RE: 290 Laurel Avenue
SBL No. 36-1-33.1 and 33.7

We have completed our review of the construction drawings entitled "290 Laurel Avenue" with the latest revision date of August 29, 2017 and offer the following comments:

METER/BACKFLOW PREVENTER VAULT

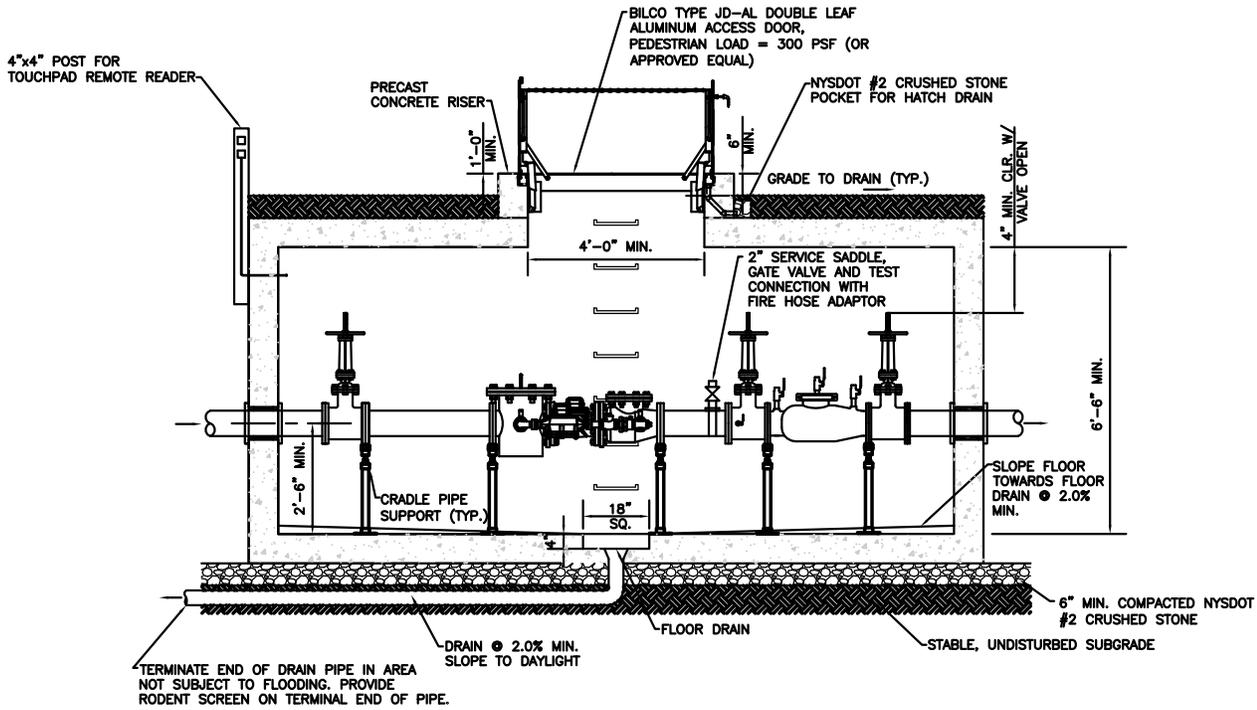
1. The fire hydrant shall be Mueller Super Centurion 200, Model A-423 with a 5 1/4" main valve opening, 2 hose nozzles, and 1 pumper nozzle. The pumper nozzle shall be provided with an integral "Storz" 5" pumper connection. The hydrants shall be factory painted yellow.
2. Provide a detail for the doghouse manhole.
3. Please replace the water meter detail with the attached.
